# USB Type-C ENGINEERING CHANGE NOTICE

**Title: Fix TBT3 Discovery and Entry Flow for Gen4 or Better Passive cables**

**Applied to: USB Type-C Specification Release 2.2, October 2022**

### (a). Figure F-1

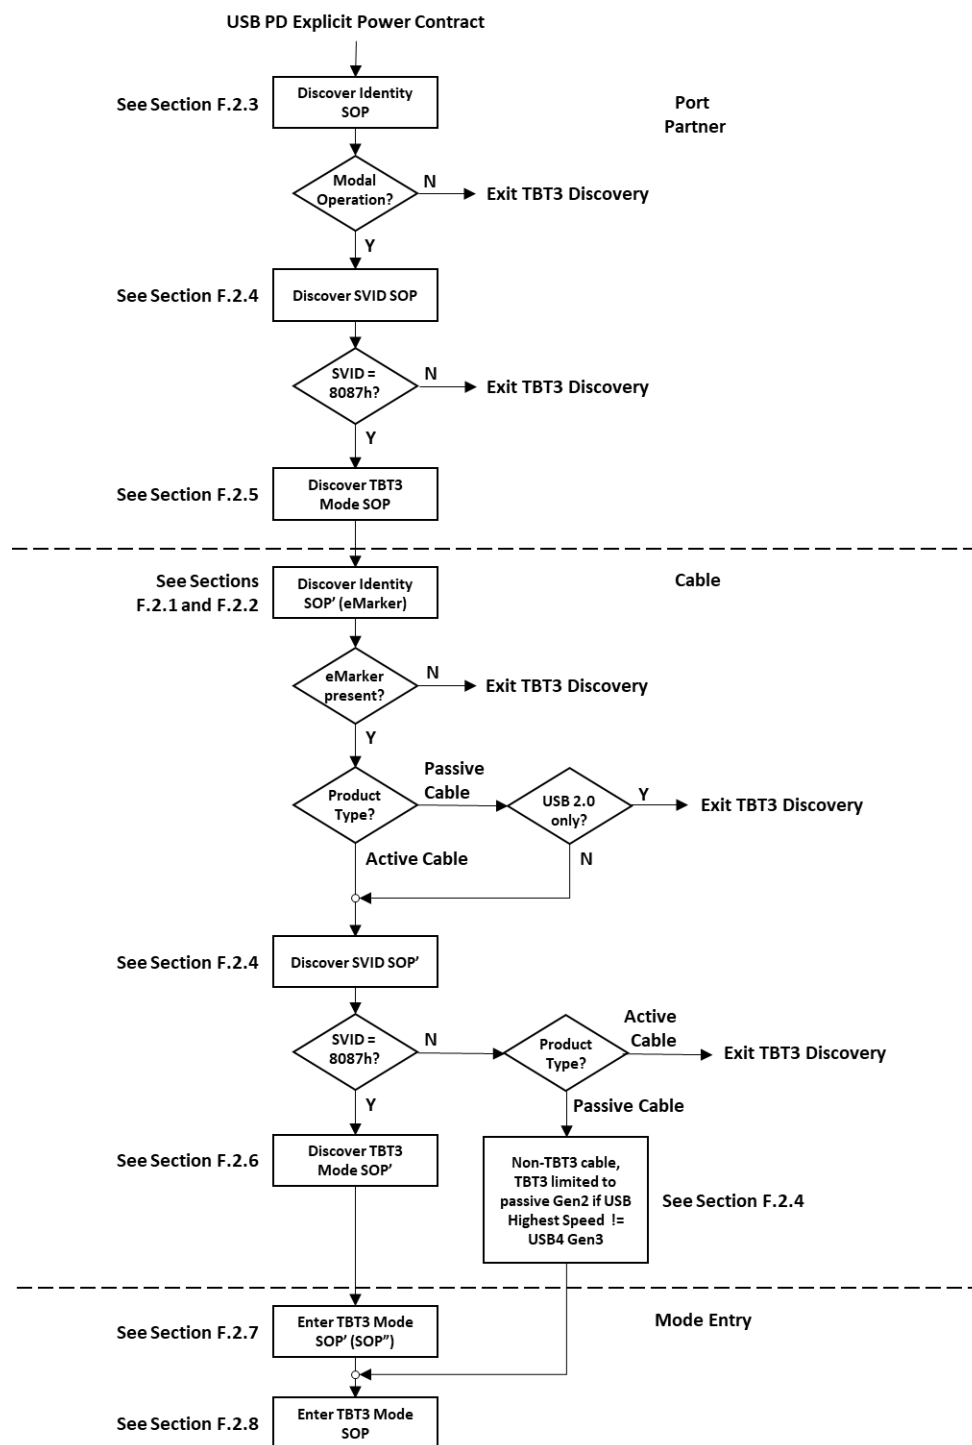
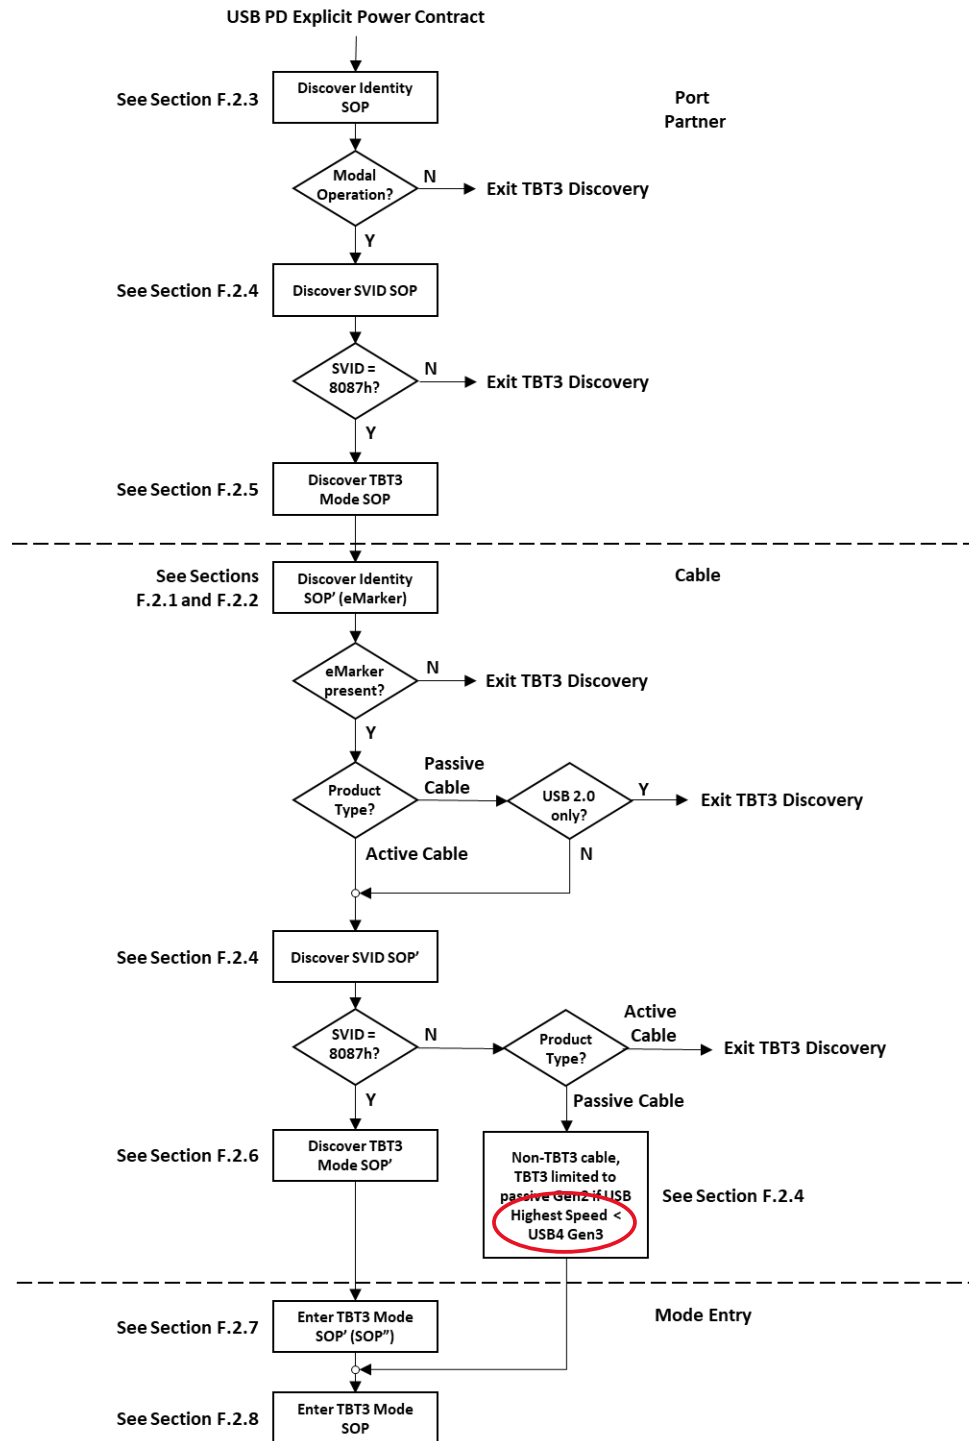
<b>Brief description of the functional changes proposed:</b>
Minor edit to the Thunderbolt 3 Compatibility Discovery and Entry flow to consider the Gen 4 USB Speed passive cables as capable of TBT3 Gen 3 performance.

<b>An assessment of the impact to the existing revision and systems that currently conform to the USB specification:</b>
Current spec prescribes a strict equal-to or not-equal-to comparison of USB Speed of USB4 Gen 3 to determine if TBT3 Gen 3 performance is appropriate. Systems built with this may require a software or firmware update to make sure they don't mistakenly restrict to 20Gbps when a value of 100b is seen.
